Colorado Springs Utilities

**Subject: South Raw Water Pipeline 3 (S3) Construction Restoration, Southern Delivery System (SDS), 1041 Permit No. 2008-002**

**SUBJECT:** Responses to Total Terrain's Site Review of S-3 Revegetation and Erosion Control, Dated October 1, 2012

**Attachment B**  
**Walker Ranches Cross-sections**

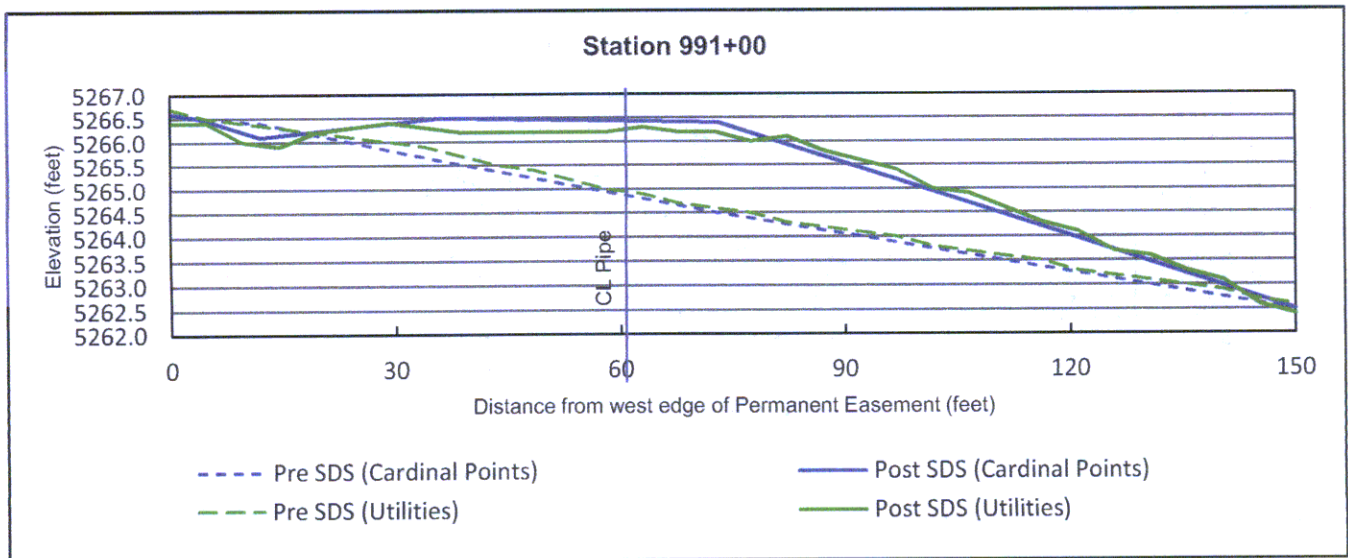
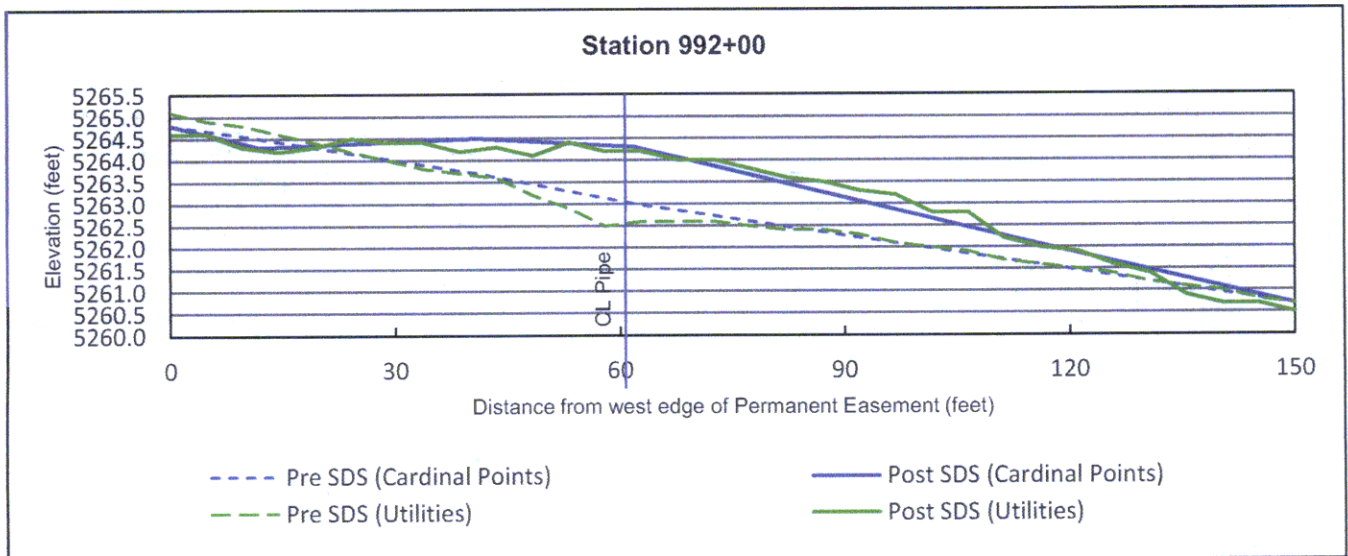
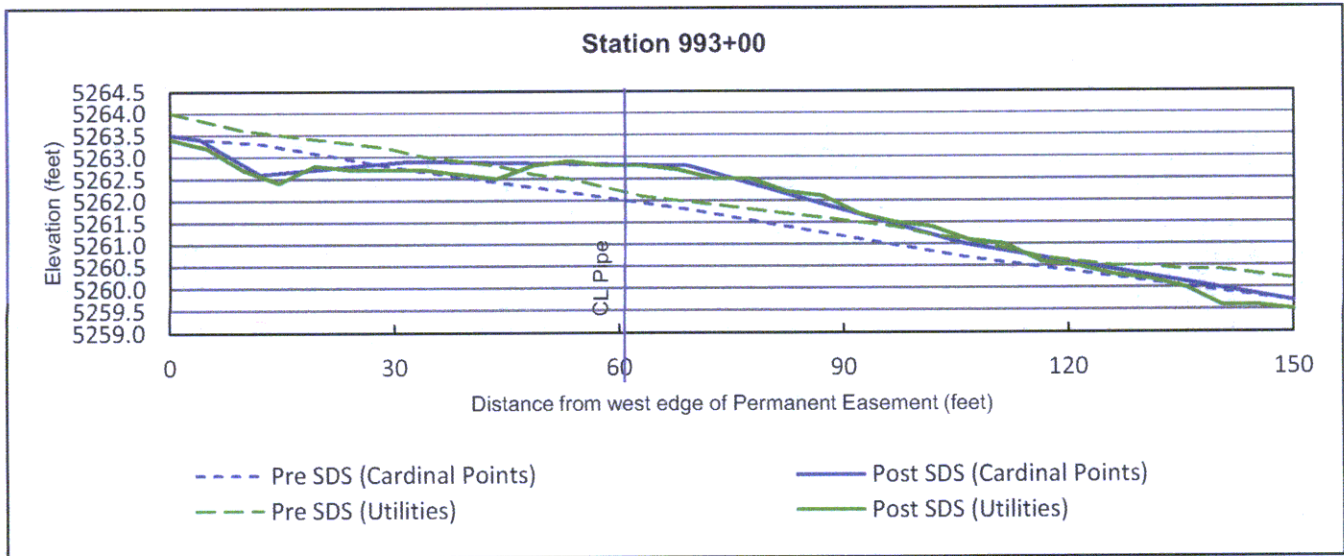
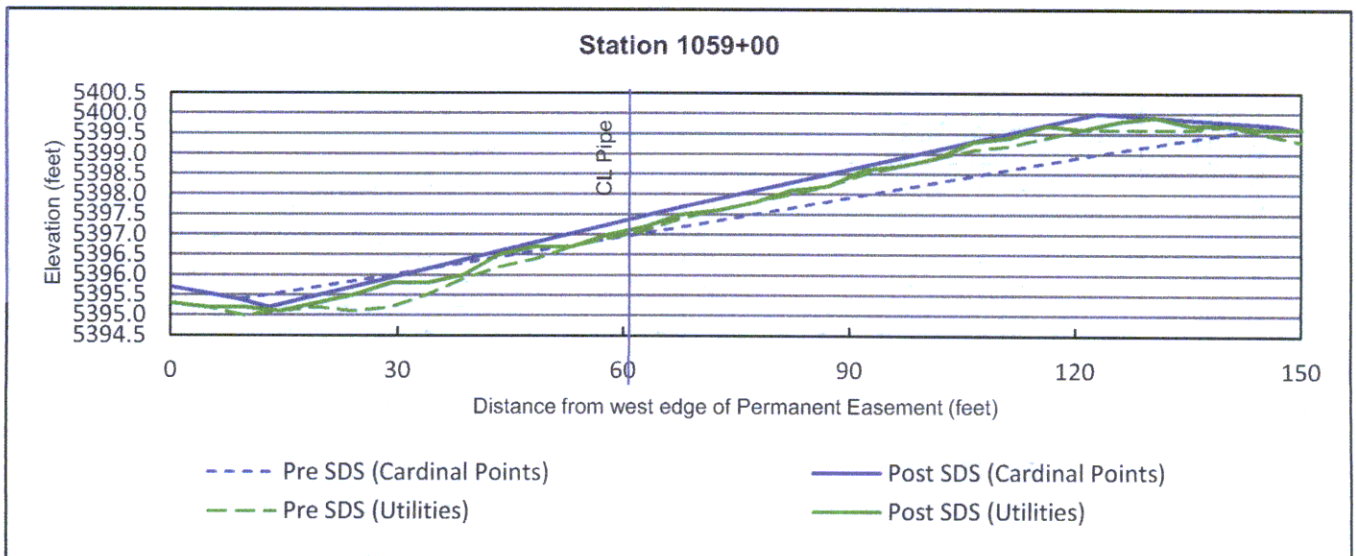
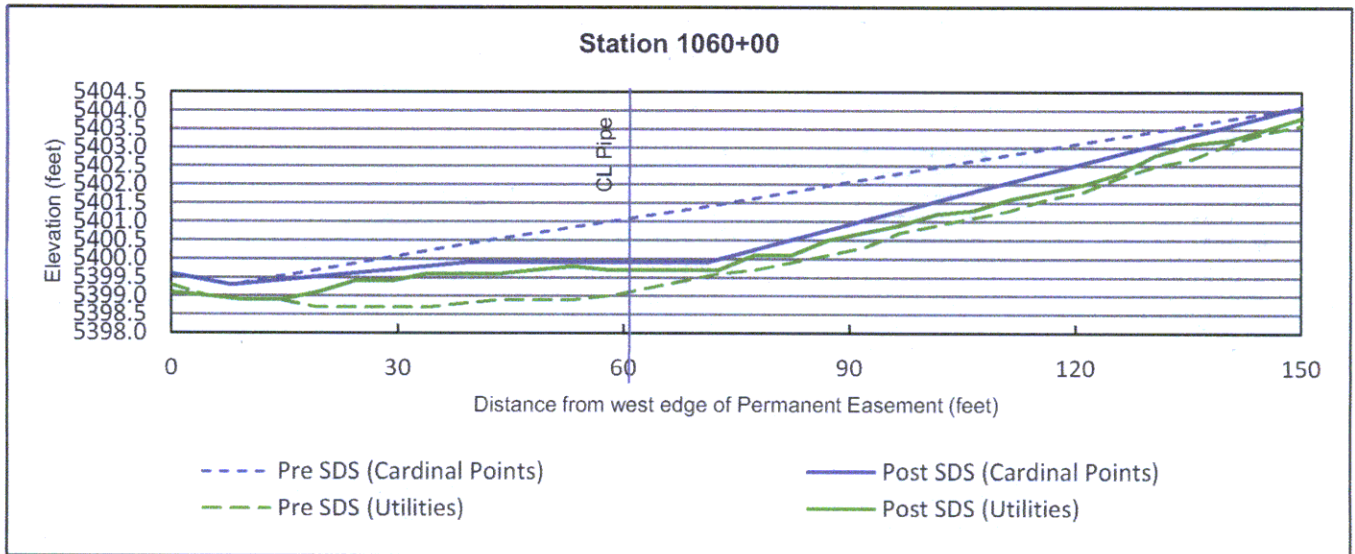
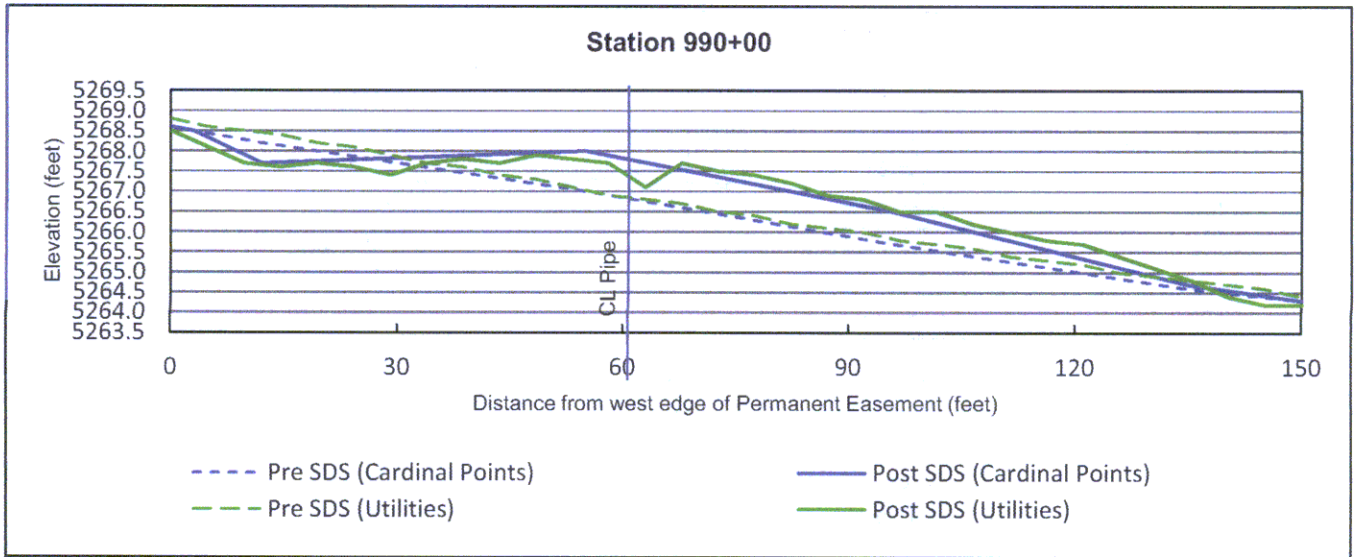
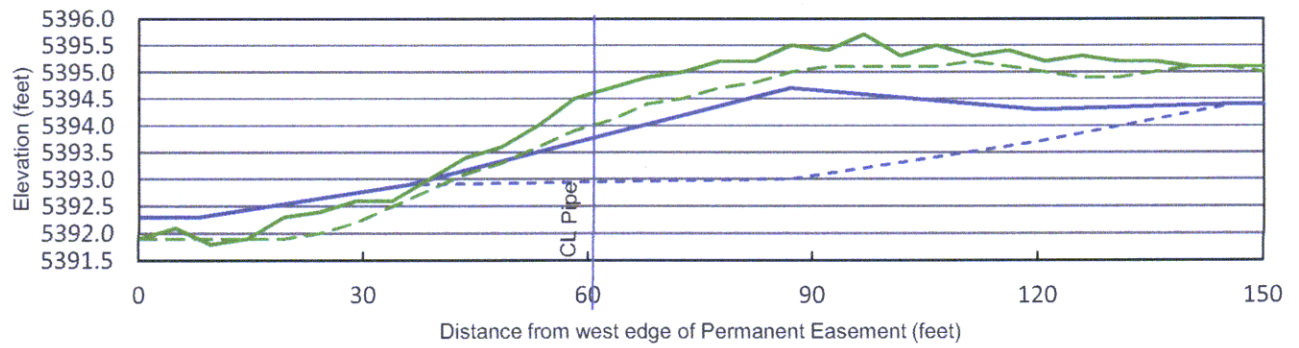
On October 2, 2012, Cardinal Points Surveying, Inc. collected cross-sectional surveys at 19 locations along the S3 alignment within Walker Ranch. Pre-construction grade was represented by a straight line between survey points measured after construction and at the outer edges of the construction area. Post-construction grade was determined by survey of about two to five points between the outer edges of the construction area for each cross-section.

Cardinal Points' data were compared to co-located (by pipeline station number) SDS pre-construction and post-construction survey data described above. Figures of those comparisons are provided in Attachment B. Cardinal Points' pre-construction cross-sections were inconsistent with the SDS pre-construction survey except where the construction area approximated a plane. Elevation variation across the construction area was, as would be expected based on the Cardinal Points' survey approach and timing, absent from their data. Consequently, the Cardinal Points pre-construction cross-sections are unsuitable for evaluating post-construction grading. Cardinal Points' post-construction cross-sections were similar, though with less resolution, to cross-sections prepared using the SDS post-construction data.
